This is to certify that SHALOM HOUSE INC /The Maxter Company

has permission to 2 Story, Wood framed single family Gr

AT 98 GILMAN ST

98 Gilman St.  
Shalom House  
**Staff Review Checklist**

1 SITE PLAN  
SCALE: 1" = 10'-0"

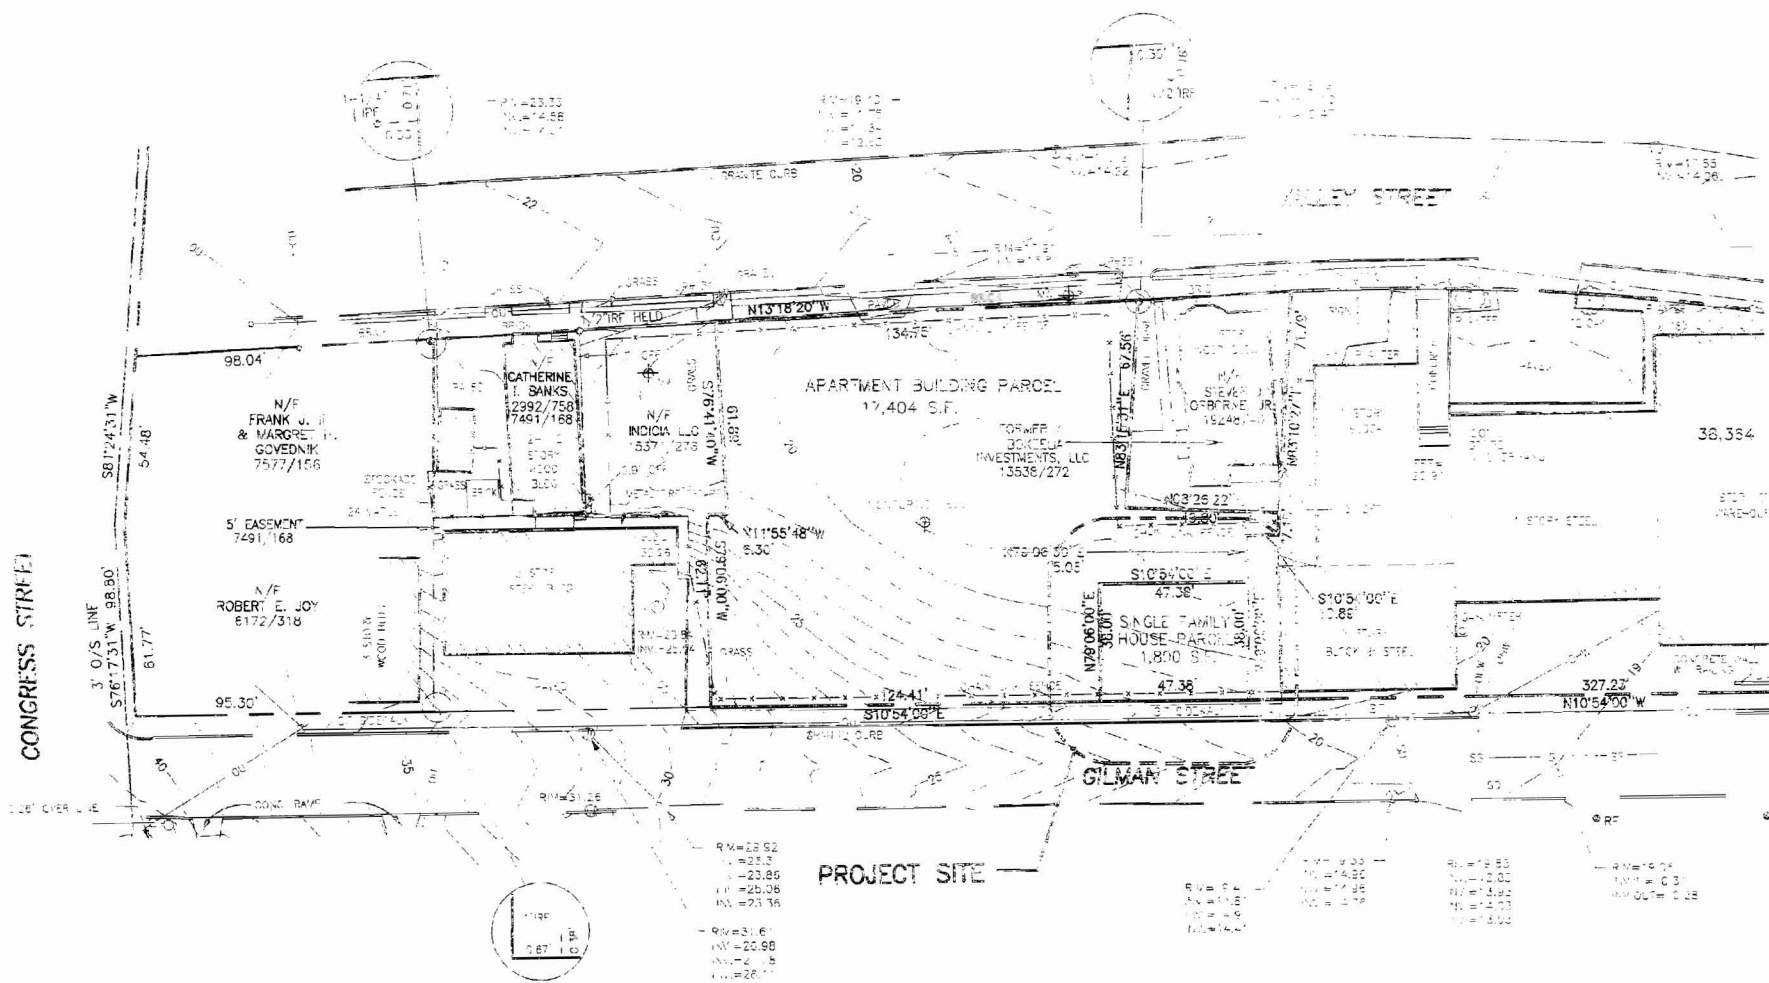
1/16/2007-mes: called Steve Keltonic of Thaxter Co. who applied for the permit. He needs to show 1 off-street parking space for this project - none shown on the plans. Also should show ramp easement from adjoining lot into new SFH. He called back later and let me know that the parking space was right behind the building on the adjoining lot and is shown on plan A-1.0.

~~None~~ ~~front~~ Off-street Parking - <sup>(one)</sup> CARS req for each D.U. - 1 pkg space shown right behind Bldg see plan A-1.0 1/16/07

OK  $\rightarrow$  min floor area, 400<sup>#</sup> - showing 1st floor of 34' x 44' = 1496<sup>#</sup>  
 $\rightarrow$  should show easement from the RAMP going up to Bldg from side lot

R-7 Zone requires to show one off-street parking space and none is shown on the submittal. I called Steve Keltonic at the Thaxter Co. notifying him of such. Permit is on hold until I receive. All other R-7 Zoning requirements are being met. I also noted that planning should get an easement from the abutting lot (same owner) for the ramp going to the new SFH. Later in the day, SK got back to me and showed me the parking space right behind the building on the adjoining lot that is also owned by Shalom House on plan A-1.0.

Barbara,  
I have had a response from the applicant concerning this submittal (#2007-0003). They did show me a parking space right behind the building on plan A-1.0  
Marge
